Access Compliance Report

Public Rights-of-Way

(Pedestrian Signals)

Intersection ID: N/A	Main Street:	Cross Street: N/A	Location: N/A
ADA ID: 4965400985B3	Signal Type: Two Push Buttons-Non APS	Overall Compliance: No	Severity Score: BTN 1:N/A BTN 2: N/A No BTN: N/A
Codes/Mitigation Info/Possible Solution		Field Measurements/Component Compliance

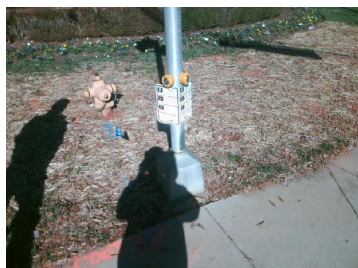
PROW/ADA: TMUTCD 4e.08, R404.2, R406.2

Yes	B 1 Clear Xing Direction?	ClearlyMarked	Yes	B 2 Clear Xing Direction?	ClearlyMarked
	B 1 Crossing Direction	To SW		B 2 Crossing Direction	To SE
No	B 1 DistanceTo XWalk (in)	66.0	No	B 2 DistanceTo XWalk (in)	111.0
No	B 1 DistanceTo Curb (in)	99.0	No	B 2 DistanceTo Curb (in)	99.0
Yes	B 1 Diameter (in)	2.0	Yes	B 2 Diameter (in)	2.0

Possible Solutions: Replace Signal Push Button With APS Button on New Post. Remove & Relocate Sign.
